STAFF REPORT: SEPTEMBER 10, 2025 MEETING

APPLICATION NUMBER: HDC2025-00530

ADDRESS: 913 CHICAGO

SCOPE: REPLACE SLATE ROOF WITH DIMENSIONAL ASPHALT SHINGLES, REPLACE FRONT PORCH AND COLUMNS, INSTALL FENCE (WORK COMPLETED WITHOUT APPROVAL)

Staff photos, August 2025.

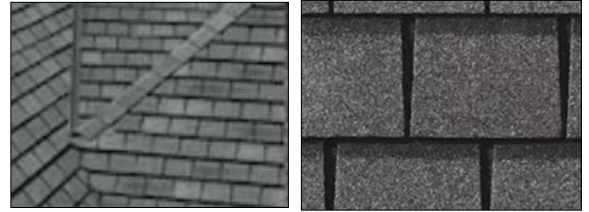
- Dimensional asphalt shingles offer only an illusion of depth, based on different patterns/perimeter shapes of the shingles and applied shading. The front view, due to irregular dimensional shapes of the shingles and sprayed on shadow lines, conveys a smaller scale mottled color and pattern, which is very different against the remaining slate tiles on the dormer walls.

Historic column

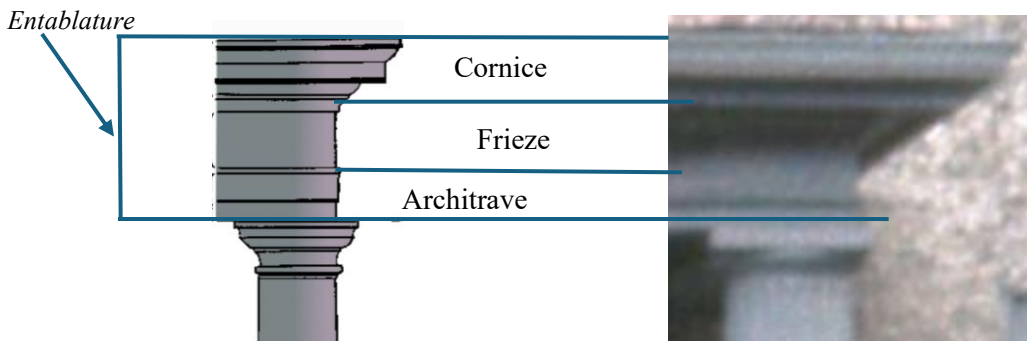
Fluting extended the full height of the shaft
Unadorned base and capital
Wide and tapered
Placed at the outer corner of roof
Plinth and abacus are present

Fluting doesn't extend to base and stops many inches from capital
Capital has decorative rings, unlike the historic column
Narrow and consistent diameter
Placed at outer corner of roof but hidden by a new fascia board
Plinth and abacus are present, but they have a different profile

- The placement of the historic capital offered a prominent view of the substantially sized columns. The columns were a dominant, character-defining feature of the property.
- The area above the original columns was the entablature, and has been removed, further destroying character-defining features of this property. The below drawing explains the many parts of a structure that makes up an entablature.

This June 2019 Google street view image is the last documentation of the shutters (three of the four) in place.

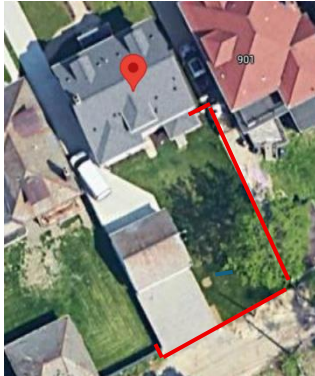
- The narrow shutters were likely wood and had a flat panel at the top with a narrow crescent moon cut out; the lower 2/3 of the shutter had ventilation strips.
- It appears that the shutters were removed between June 2019 and March 2022.
- The decorative design and placement of the shutters is a common feature within Boston Edison and can be found on many houses and is a character-defining feature of the property and district.
